**Carolina Power & Light Company**

H. B. ROBINSON STEAM ELECTRIC PLANT, UNIT NO. 2  
DOCKET NO. 50-261/LICENSE NO. DPR-23

SUPPLEMENT 1 TO TECHNICAL SPECIFICATIONS  
CHANGE REQUEST FOR ULTIMATE HEAT SINK (UHS)

CLARIFICATIONS TO THE  
TECHNICAL SPECIFICATION CHANGE REQUEST FOR  
ULTIMATE HEAT SINK

Figure 1

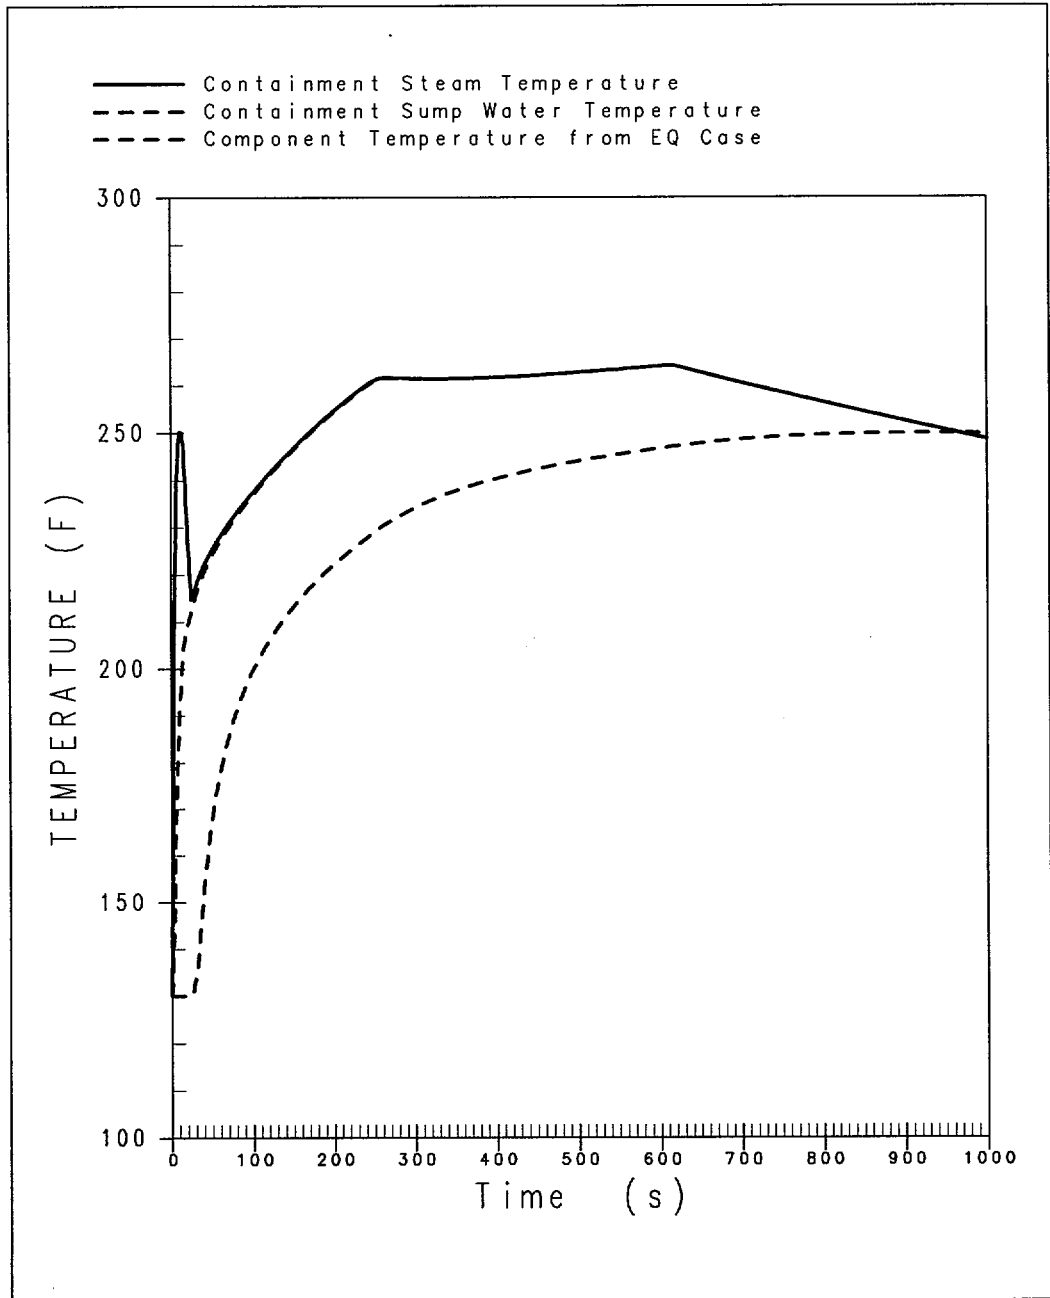
- a. The MSLB analysis result shows an early peak containment temperature as a result of superheat. This temperature is less than 280°F, the qualification temperature.

Consequently, no thermal analyses were required to qualify components to temperatures higher than the manufacturer's peak qualification temperature. The MSLB component temperature curve is included as Figure 1.

It should be noted that the UFSAR currently has a component qualification temperature of 263°F. In the current MSLB analysis there is a short temperature peak of 350°F. However, because of the short duration of the temperature peak, the surface temperature of components has been determined to not be impacted beyond the current qualification limit.
